16 September 2022

Matamata Piako District Council  
PO Box 266  
Te Aroha  
Attn Todd Whittaker

## CALCUTTA PLAN CHANGE: INITIAL TRANSPORTATION REVIEW UPDATE

This review is based on the Industrial Zone Change Integrated Transport Assessment, Calcutta Farms Ltd prepared by BBO (V4, 8 July 2022) and proposed transportation plan change provisions (2 August 2022). Our review includes:

**Figure 3: Proposed Collector Road**

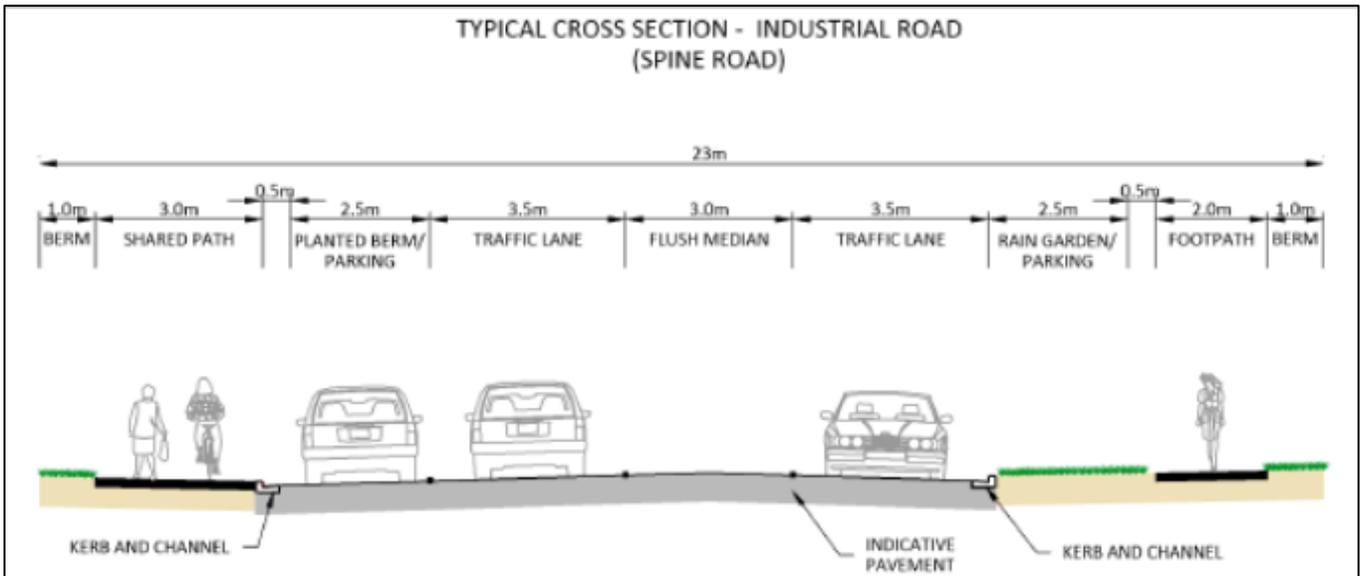
The proposed collector road cross-section is broadly aligned with the District Plan. The departures being provision of a flush median and recessed parking. Provision of a flush median will allow development of turning lanes at intersections and better provide for right turns at individual property accesses. Recessed parking is preferred to assist with speed management in the long-term where the collector road is likely to provide access to development south of the site. The proposed collector cross-section is considered acceptable.

**Figure 4: Proposed Local Road Cross Section**

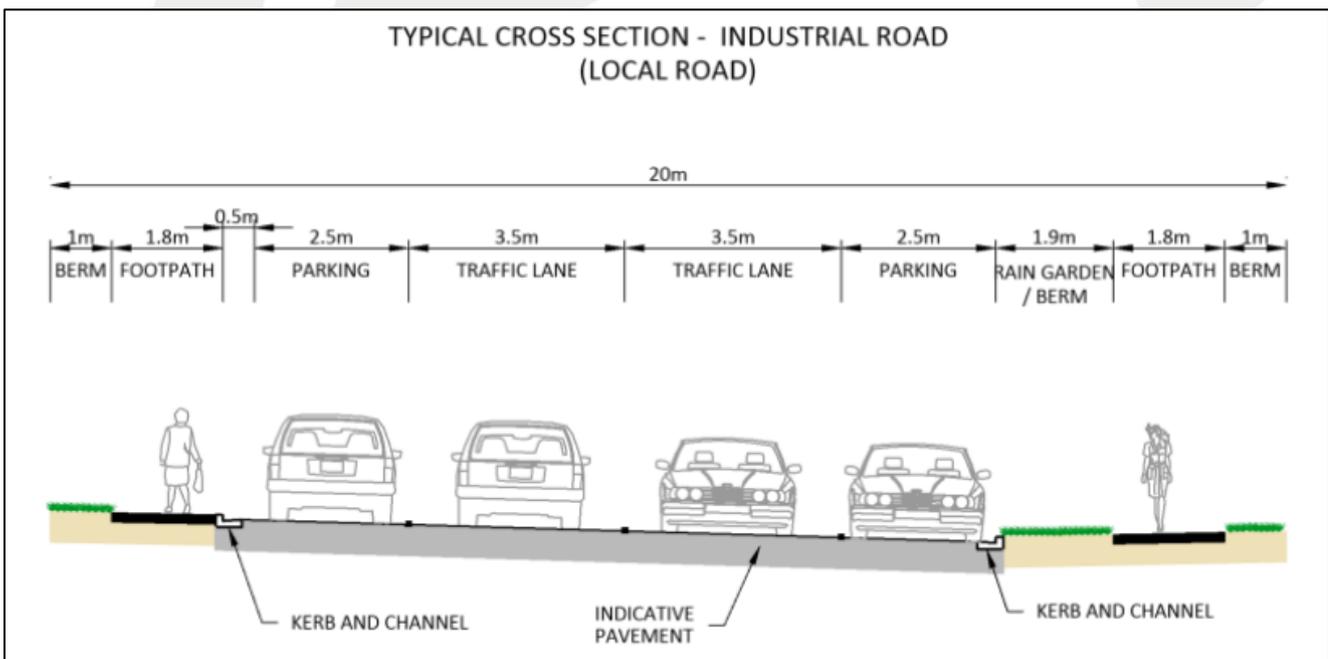
The proposed local road cross-section includes 2.5m wide parking bays on both sides of the road and two 3.5m wide lanes. No on-road cycle facilities are provided. The ITA states that the “wide road reserve can safely accommodate cyclist on road”. The lack of on-road cyclist facilities is partially offset by the provision of an off-road walking and cycling network. We consider the proposed local cross section to be acceptable.

**Figure 5: Pedestrian facilities along SH24 (extract from SH24 Roundabout Access Overall Plan, 146930-02-0221 Rev B)**

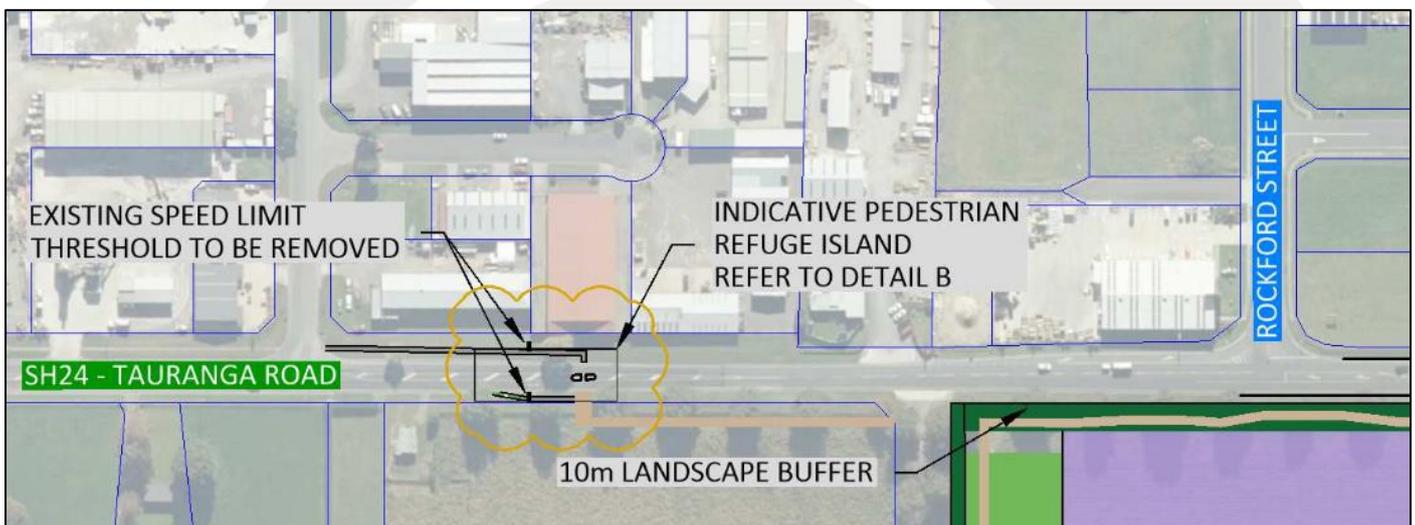
The proposal includes a pedestrian refuge island on SH24. The ITA states that Waka Kotahi have confirmed that the pedestrian crossing arrangement shown in the image below is acceptable.

The Applicant proposes that the landscape buffer and shared path along SH24 is owned and maintained by the Applicant. It is unclear what ownership structure will be in place and how it will fund maintenance activities. It is also unclear how public access will be maintained. There is a risk that Waka Kotahi or MPDC will inherit ownership and maintenance of the landscape buffer. We understand that where the speed limit on a state highway is less than 70km/h, the Waka Kotahi is only responsible for maintenance of the carriageway with the local council responsible for maintenance of berm and footpaths etc.

a)	A 3m wide shared path, along the site's frontage from the new roundabout to a point approximately 115m west of the north-western point of the site, and with a raised safety platform zebra crossing at that location.	Provision does not match the proposed pedestrian crossing layout. The provision should be updated to match revised pedestrian crossing arrangement. More clarity on staging and timing is required.
